# PIC18(L)F26/45/46K40

## PIC18(L)F26/45/46K40 Family Silicon Errata and Data Sheet Clarification

The PIC18(L)F26/45/46K40 devices that you have received conform functionally to the current device data sheet (DS40001816F), except for the anomalies described in this document.

**Figure 1. 28-pin SPDIP, SSOP, SOIC**

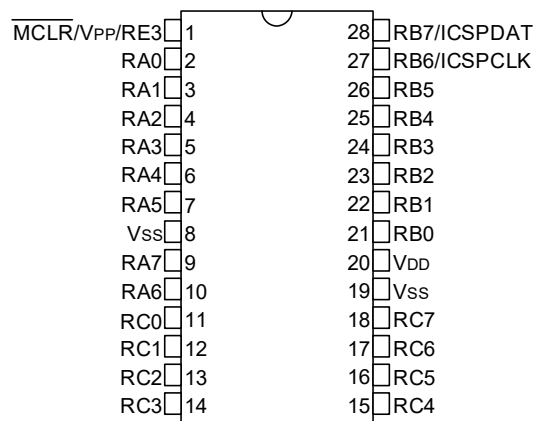
The correct marking for pin 26 on the 28-pin SPDIP/SSOP/SOIC package is **RB5**.

**Figure 3. 40-pin PDIP**

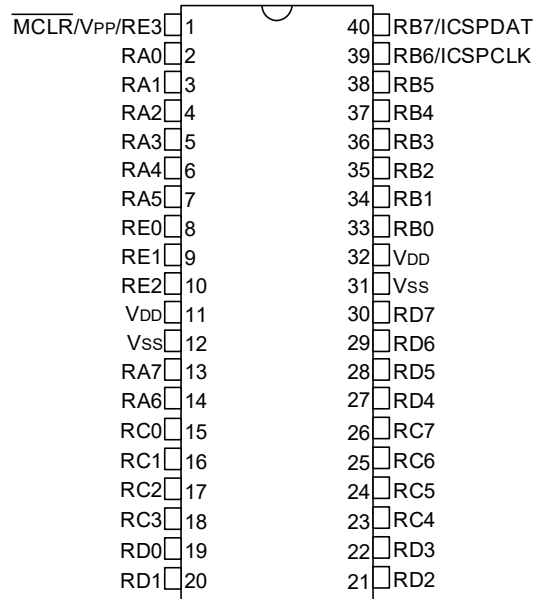
The correct marking for pin 38 on the 40-pin SPDIP package is **RB5**.

**Figure 38-10: ADC Conversion Timing (ADC Clock F<sub>OSC</sub>-Based)**

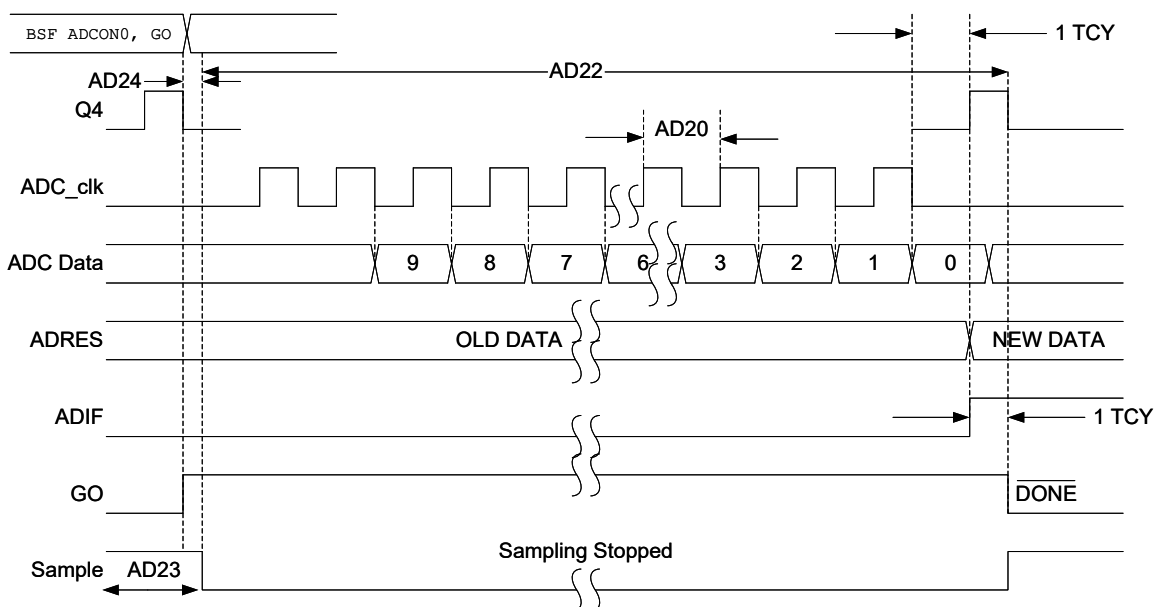
Refer to the images below for corrections of Figure 38-10 and Figure 38-11. Previously, the parameter numbers were incorrect.
